Access Compliance Report

Public Rights-of-Way

Intersection ID: 13277	Main Street: SPRUCE_ST	Cross Street: WILMORE_DR	Location: SE
ADA ID: 805519049BCE	Ramp Type: PerpDiag	Initial Pass/Fail: Fail	Overall Compliance: No
Severity Score: 12.5			
Codes/Mitigation Info/Possible Solution		Field Measurements/Component Compliance

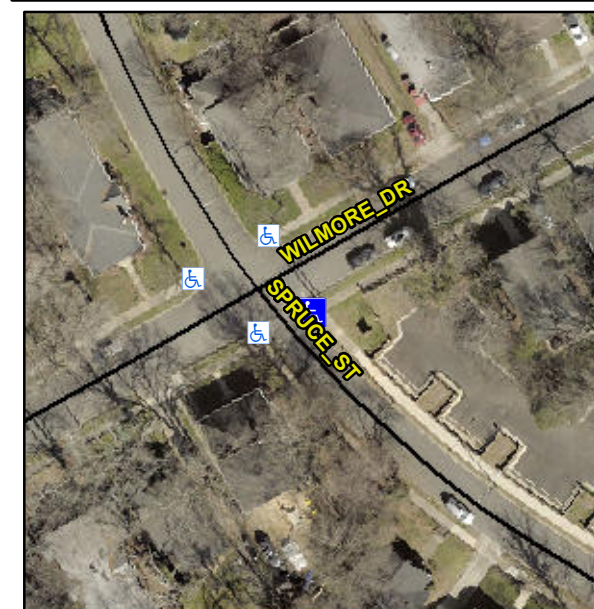
Not Found, R304.2.2

Compliance	Description	Data	Compliance	Description	Data
N/A	Ramp Length (in)	76.0	No	Ramp Slope (%)	9.4
Yes	Ramp Width (in)	48.0	Yes	Ramp XSlope (%)	1.6
N/A	Flare Type LT	N/A	N/A	Flare Type RT	N/A
N/A	Flare Slope LT (%)	N/A	N/A	Flare Slope RT (%)	N/A
N/A	Flare Traversable LT?	N/A	N/A	Flare Traversable RT?	N/A
N/A	Landing Length (in)	N/A	N/A	DWS Provided?	N/A
N/A	Landing Width (in)	N/A	N/A	DWS Contrast?	N/A
N/A	Landing Slope (%)	N/A	N/A	DWS Length (in)	N/A
N/A	Landing X Slope (%)	N/A	N/A	DWS Full Width?	N/A
N/A	Landing Curb? (Y/N)	N/A	N/A	DWS Offset (in)	N/A
N/A	Shared Landing?	N/A			
N/A	Gutter Ponding?	N/A	N/A	Gutter Slope (%)	N/A
N/A	Gutter Lip Ht (in)	N/A	N/A	Gutter X Slope (%)	N/A
N/A	Painted X Walk1?	No	N/A	Painted X Walk2?	No
	X Walk 1 Direction	To NW		X Walk 2 Direction	To W
N/A	X Walk 1 Width (in)	N/A	N/A	X Walk 2 Width (in)	N/A
	X Walk 1 Slope (%)	0.5		X Walk 2 Slope (%)	1.3
	X Walk 1 X Slope (%)	0.4		X Walk 2 X Slope (%)	0.6

Remove & Replace Curb Ramp With Two New Directional Ramps or Equivalent.
